UN#12-127

Subject: UniStar Nuclear Energy, NRC Docket No. 52-016
Supplemental Response to Request for Additional Information for the
Calvert Cliffs Nuclear Power Plant, Unit 3,
RAIs 284 and 322, Vibratory Ground Motion and
RAI 345, Vibratory Ground Motion, COLA Markups

**COLA Markup Error Identified in RAI
Response letter UN#12-102, dated September 27, 2012
Calvert Cliffs Nuclear Power Plant, Unit 3**

Figure 2.5-47 - {Master Logic Tree of the CEUS SSC Model}

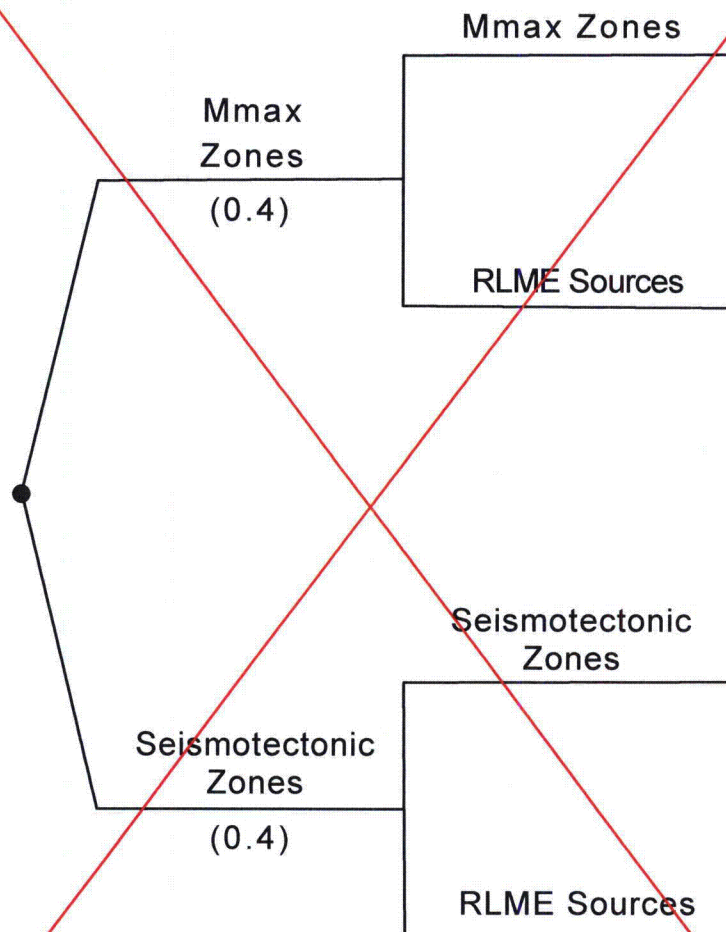
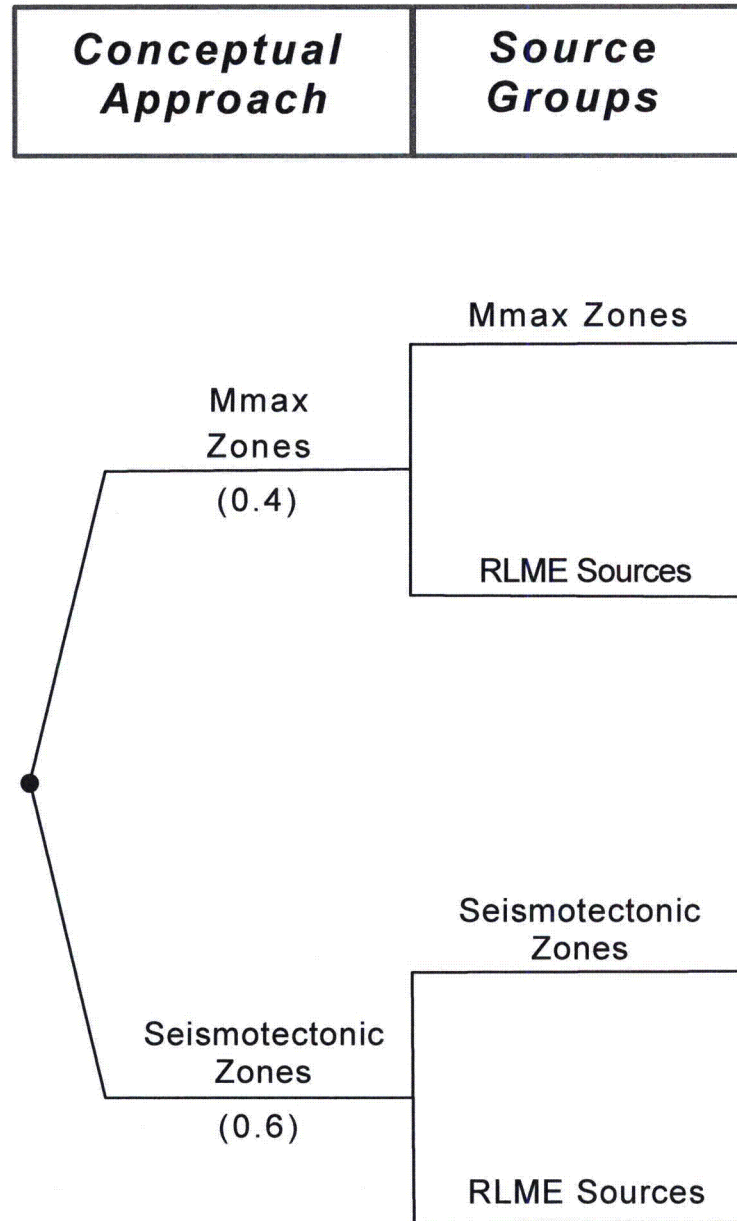
Insert 1
